ADDENDUM NO. 5 TO PROJECT NO. 45124

**CONSTRUCTION WORK, HVAC WORK, PLUMBING WORK, AND ELECTRICAL WORK
ABATE HAZARDOUS MATERIALS
AND RENOVATE BUILDING NO. 4
STATE OFFICE BUILDING CAMPUS
1220 WASHINGTON AVENUE
ALBANY, NY**

October 14, 2016

HAZMAT
QUANTITY

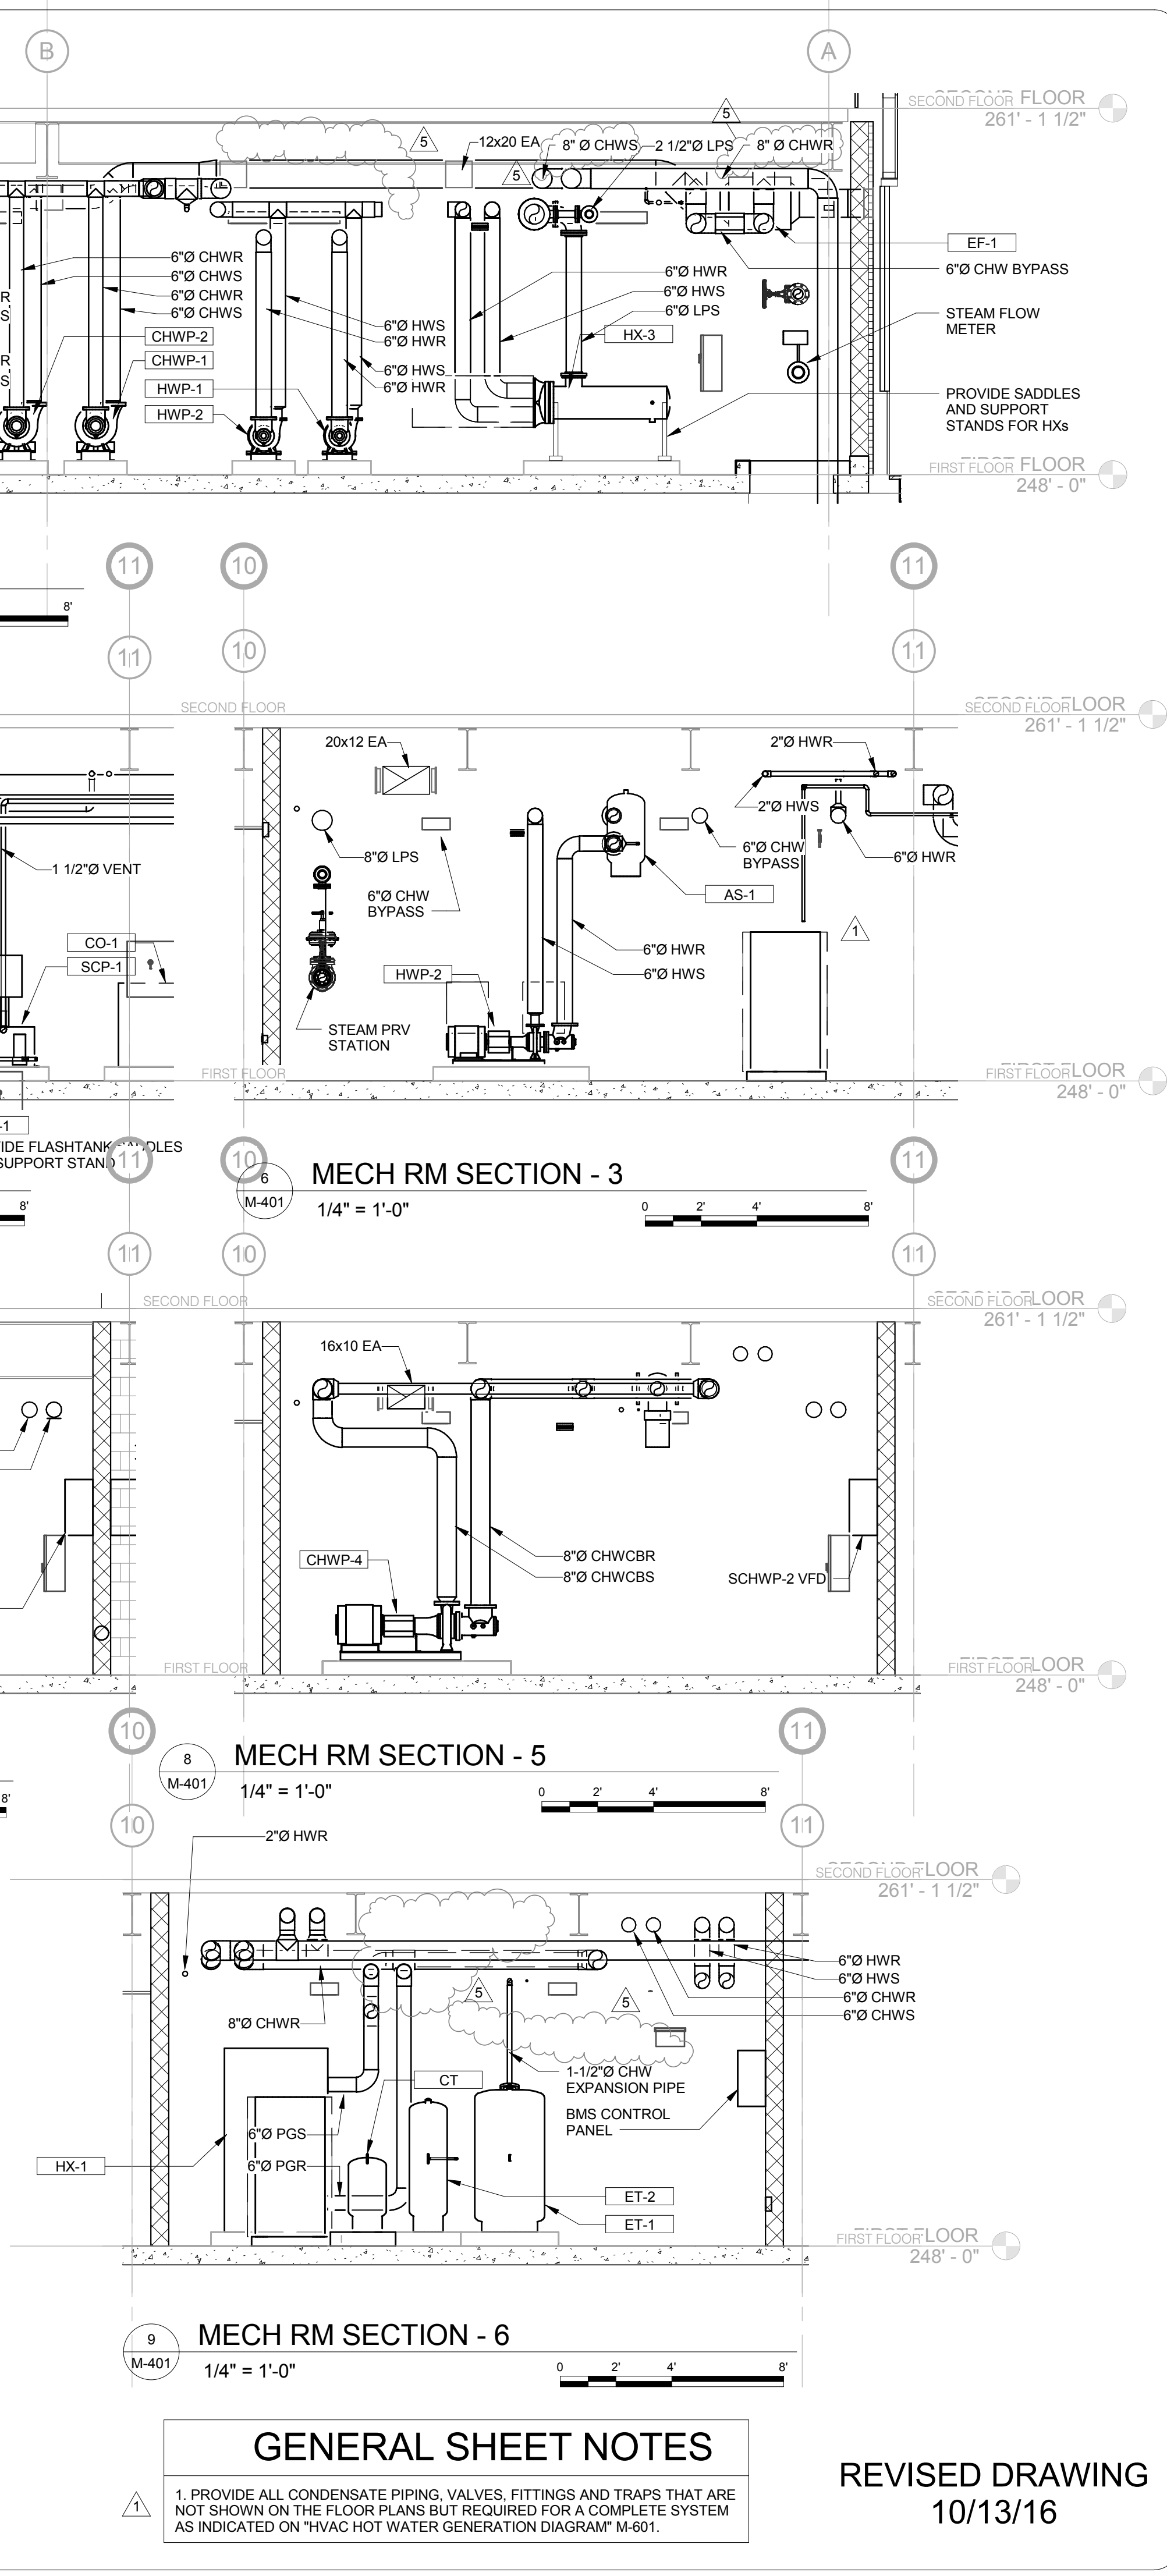
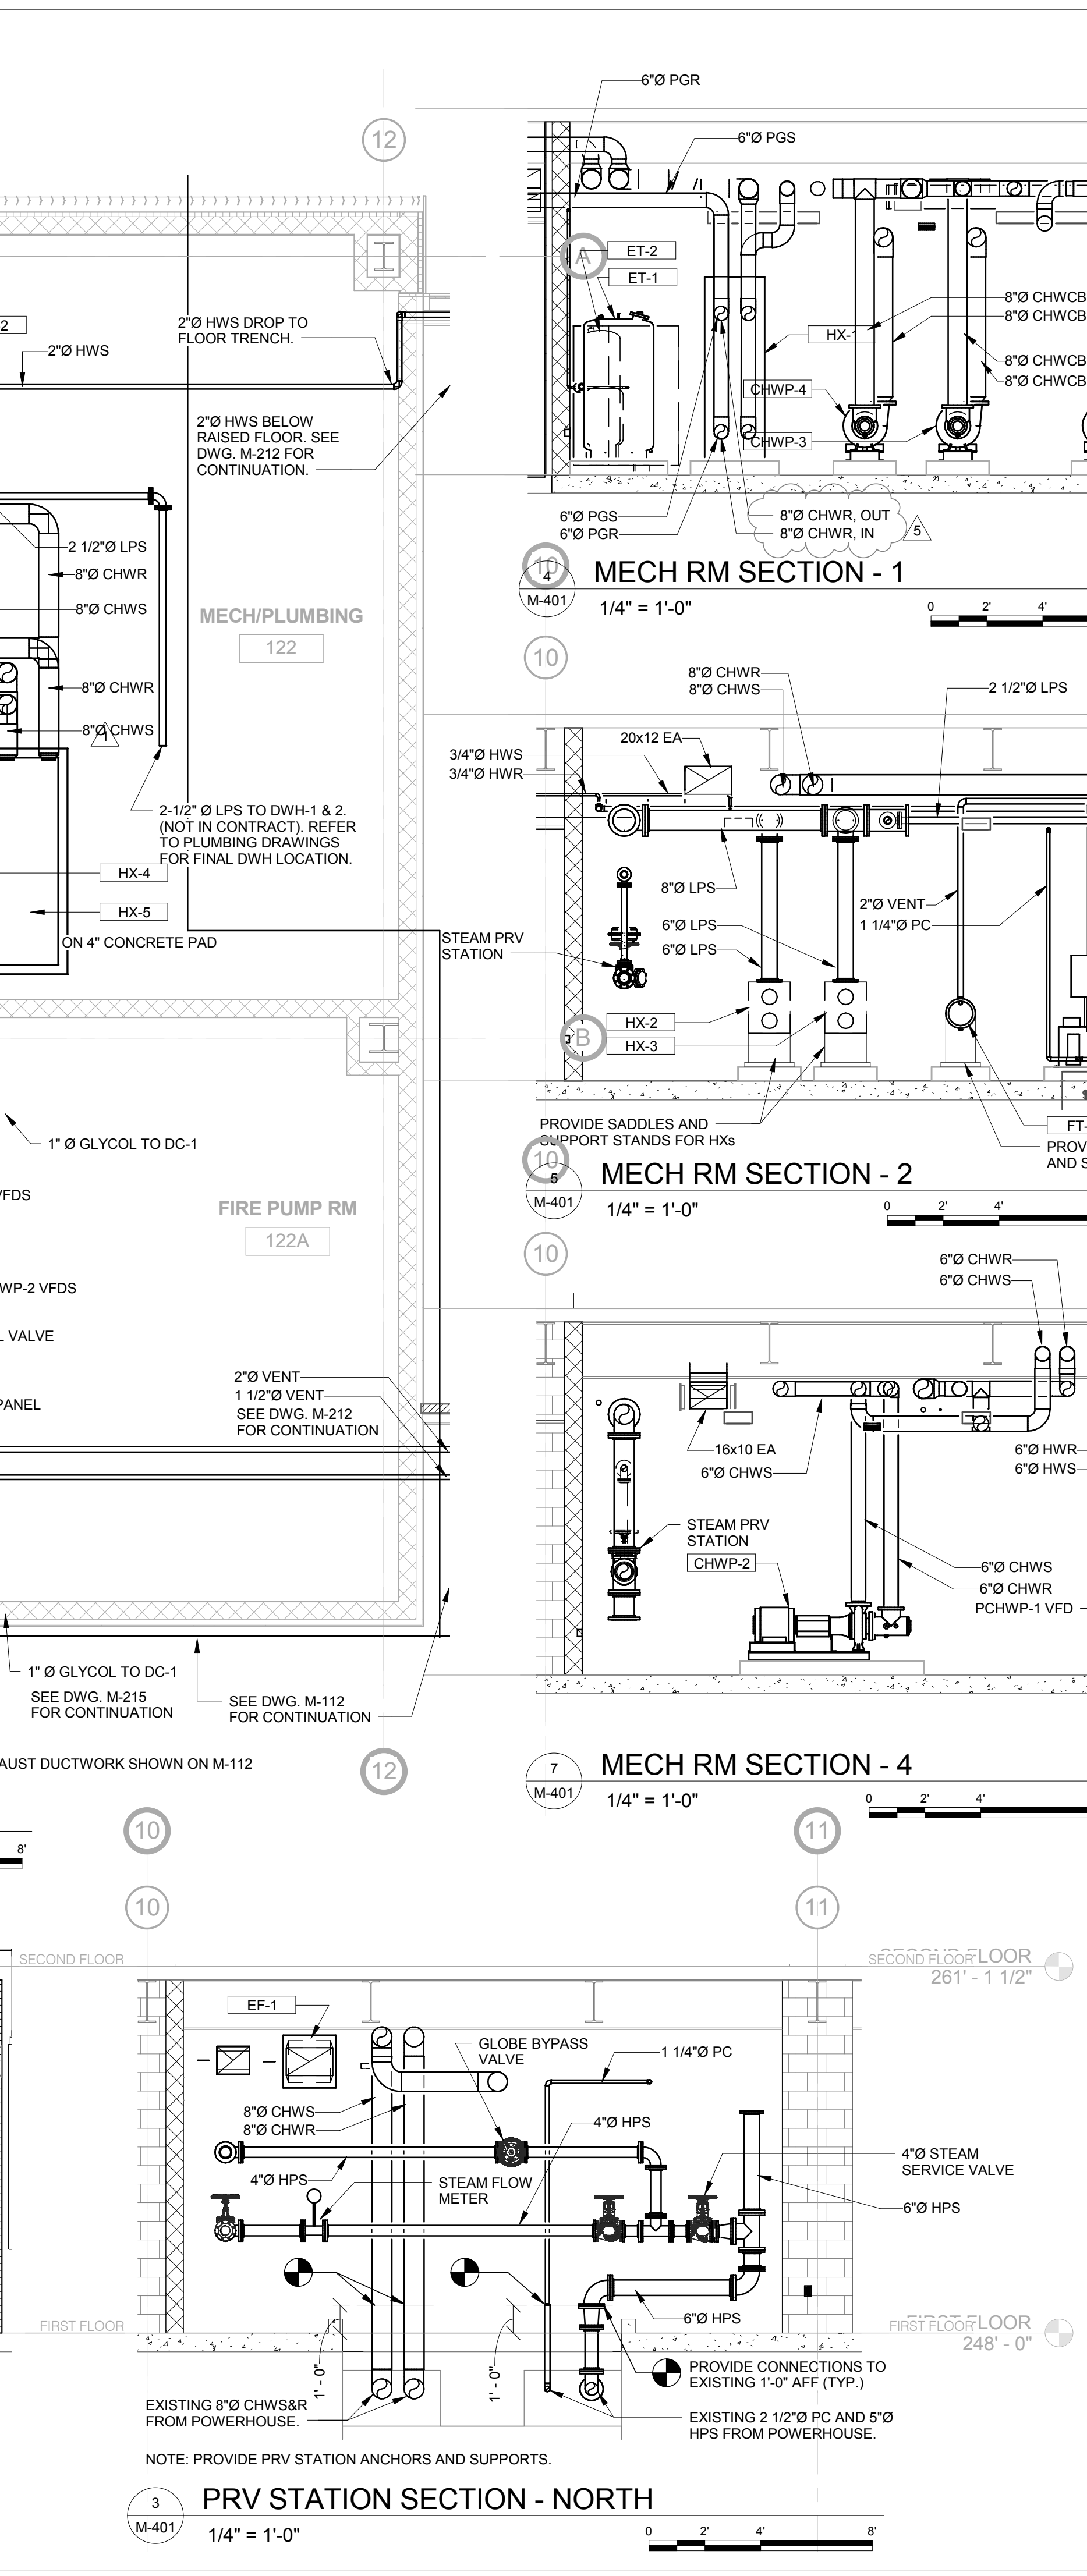
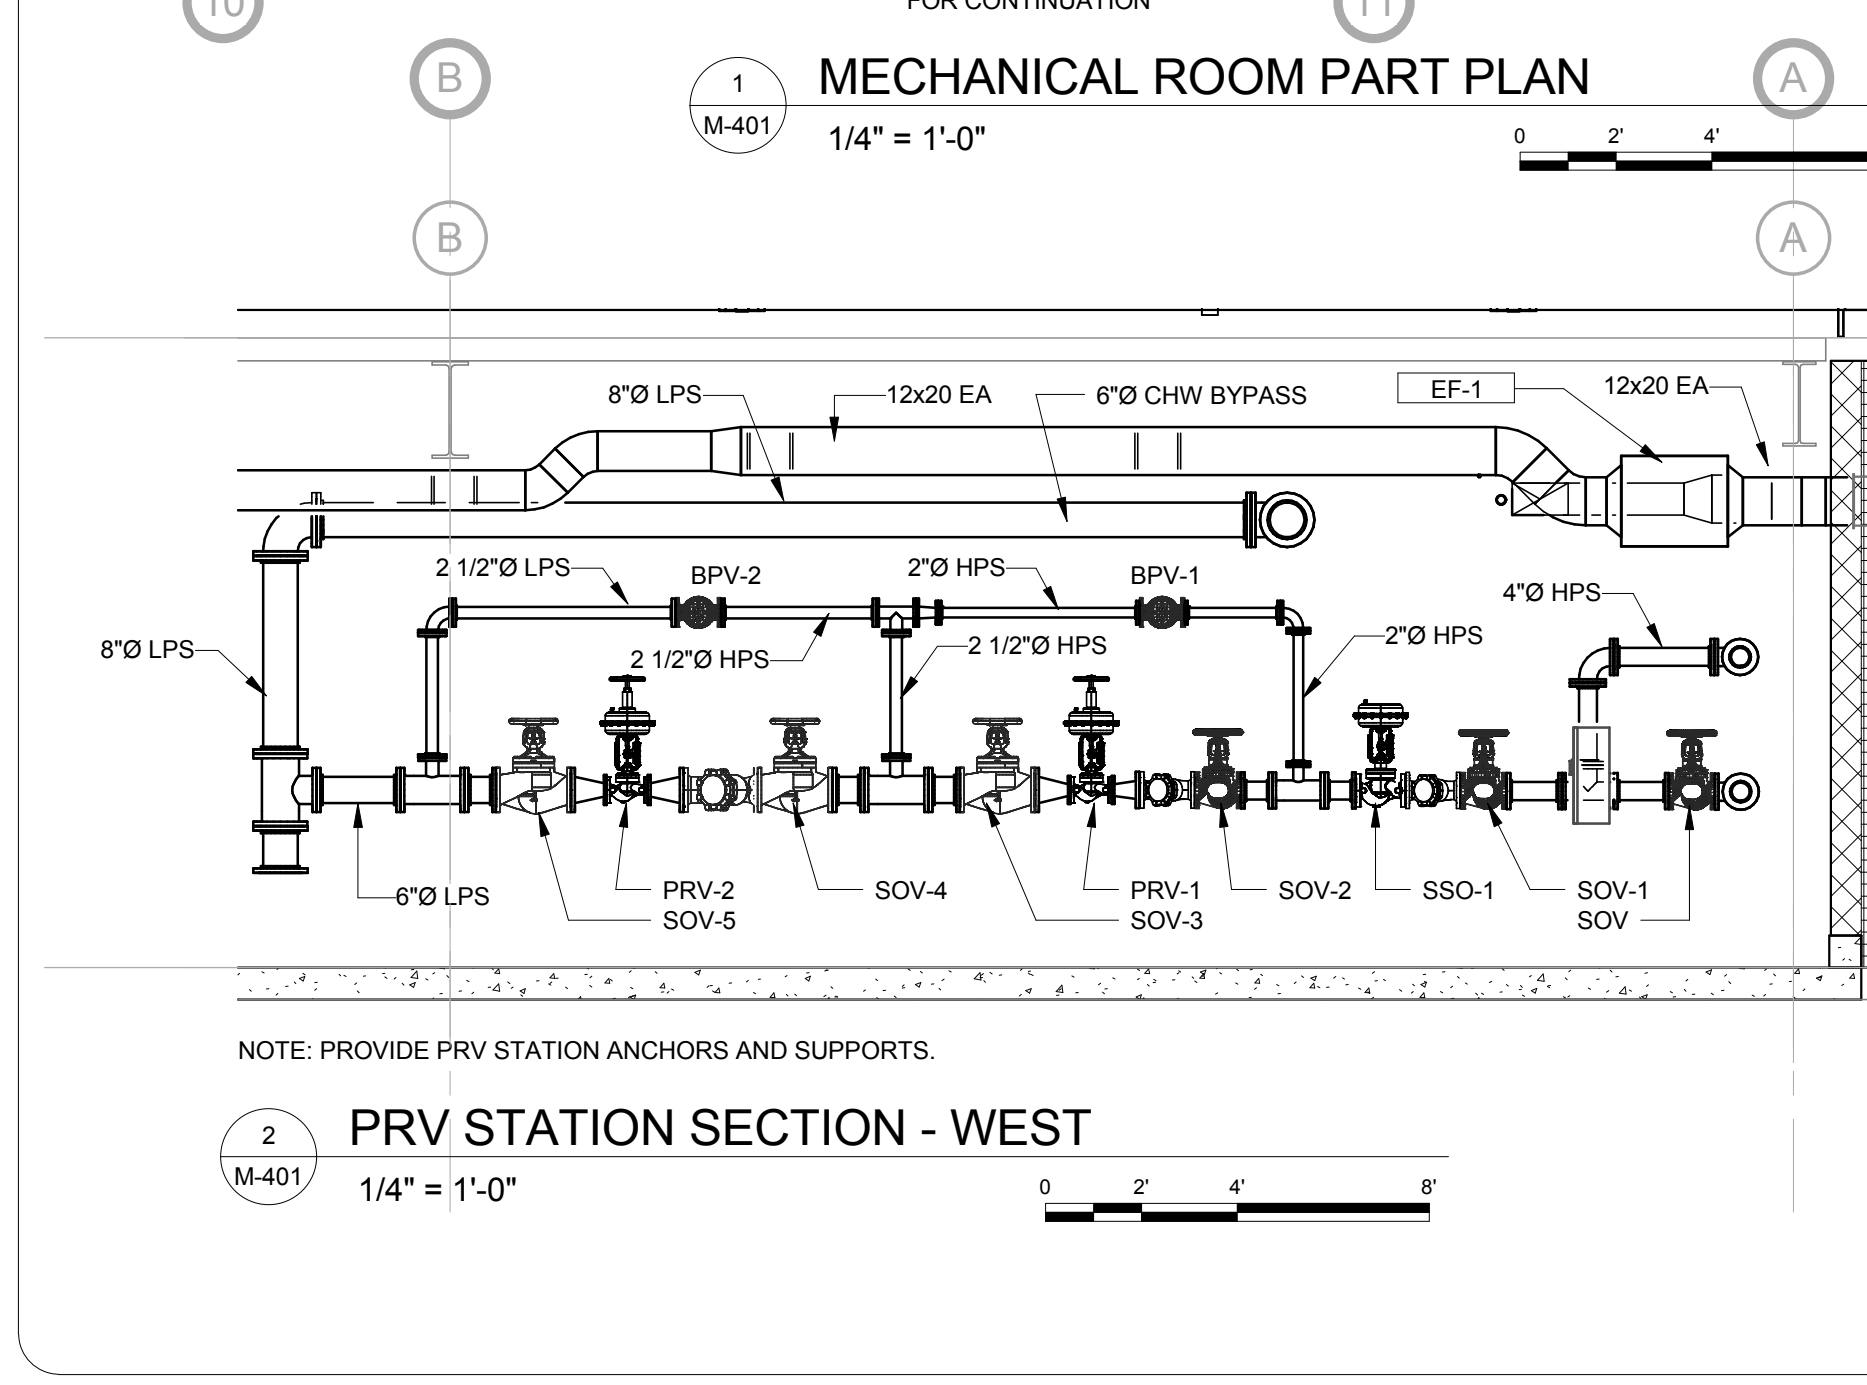
46. Revised Drawings:
- a. Drawing No. H-101 noted “REVISED DRAWING 10/13/16” accompanies this Addendum and supersedes the same numbered originally issued Drawing.
